**TRAFFIC SIGNAL  
NOTES AND LEGEND**

KAHULUI AIRPORT  
ACCESS ROAD, PHASE I  
Federal Aid Project No. NH-0380(10)  
Scale: None Date: February 2013

AS-BUILT DRAWINGS

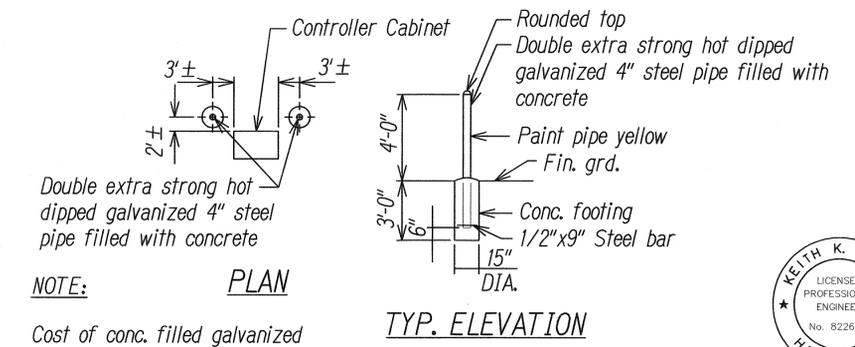
DATE	REVISION
4/5/13	Added 4-Section Head Symbol, Revised Traffic Signal Note #15

### KAHULUI AIRPORT ACCESS RD. / DAIRY RD. / PAKAULA ST. TRAFFIC SIGNAL PLAN

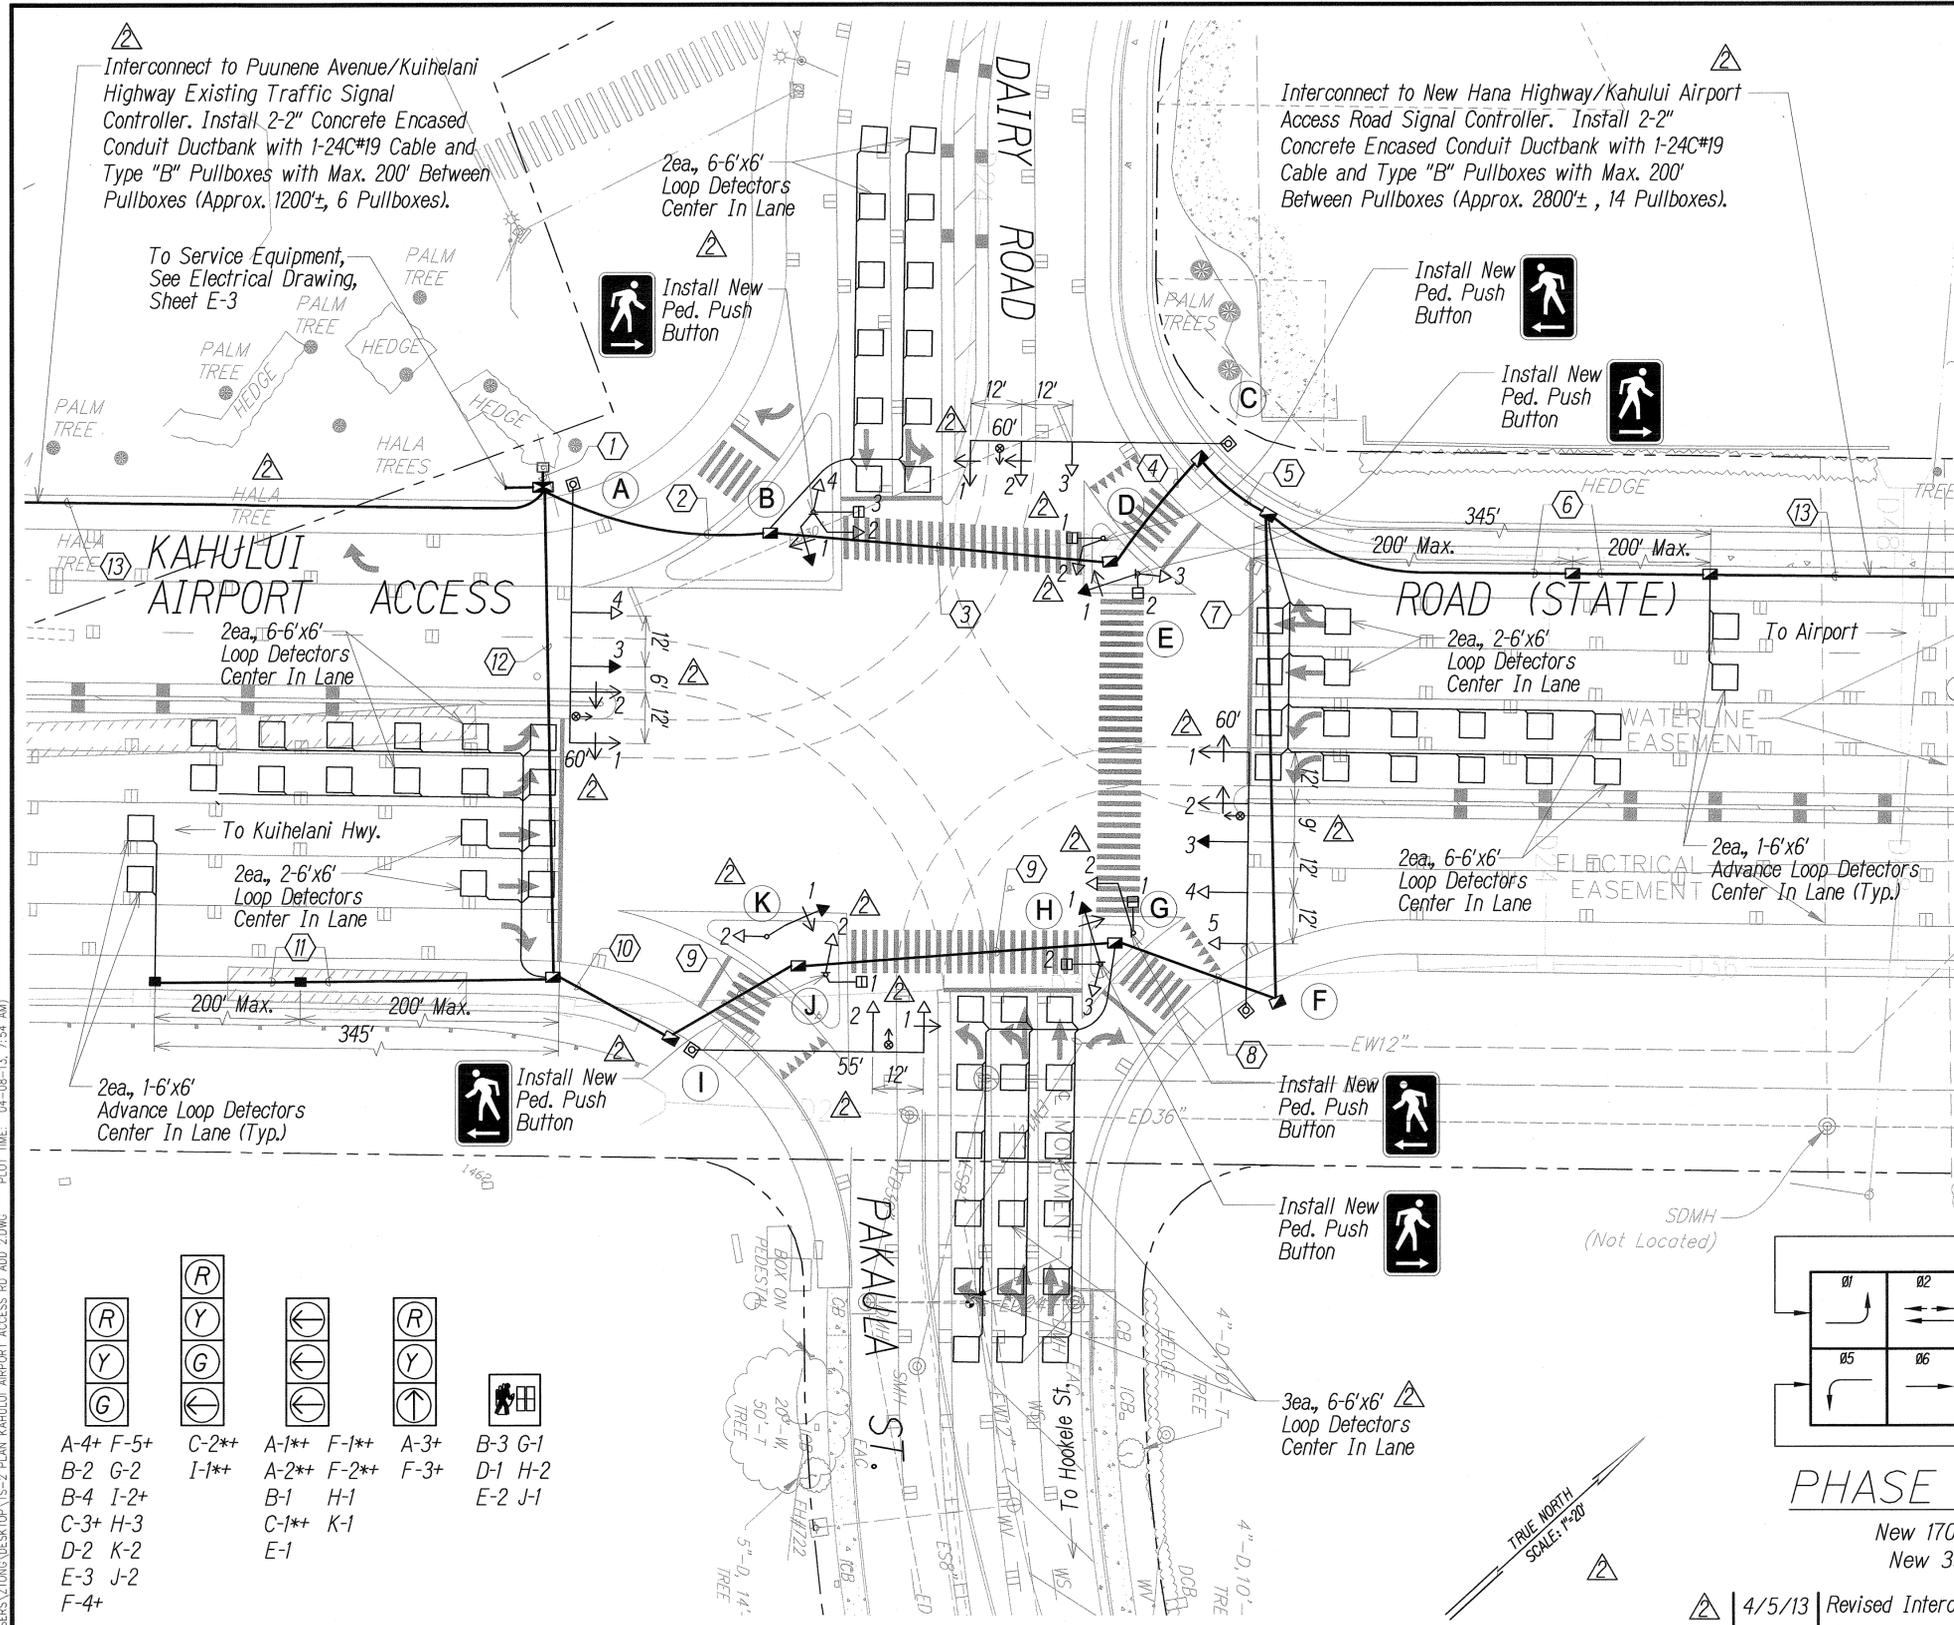
4/5/13	Revised Interconnect, Phase Diagram, Mast Arm Lengths, Conduits, Cables, Loop Detectors, Various Signal Heads, EVP, and Pullboxes.
DATE	REVISION

DRILLED SHAFT FOUNDATION FOR TYPE II MAST ARM STANDARD  
NOT TO SCALE  
(FOR MAST ARM GREATER THAN 40' IN LENGTH)

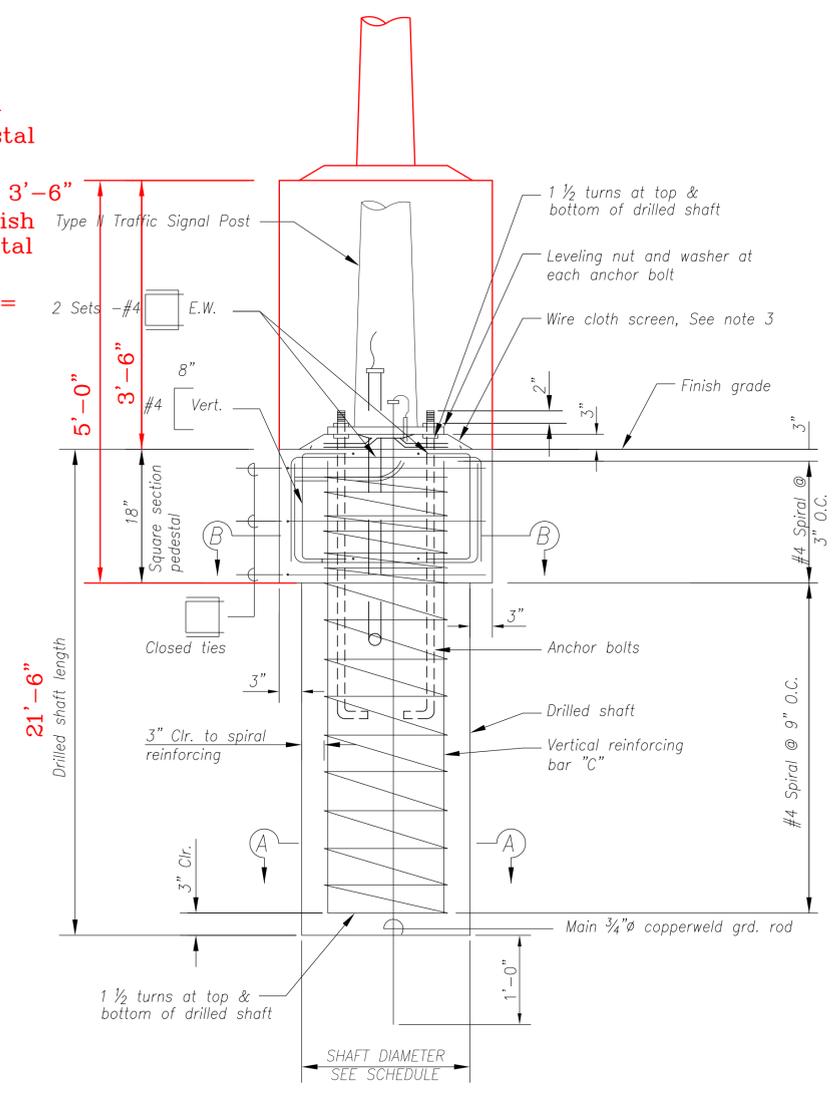
RFI #32  
9/24/14

Note: All As-Built markup revisions shown are for Mast Arm "C" on TS-2 (Sheet 163)

Mast arm "C" Pedestal on TS-2 extended 3'-6" above finish grade. Total height of pedestal = 5'-0"
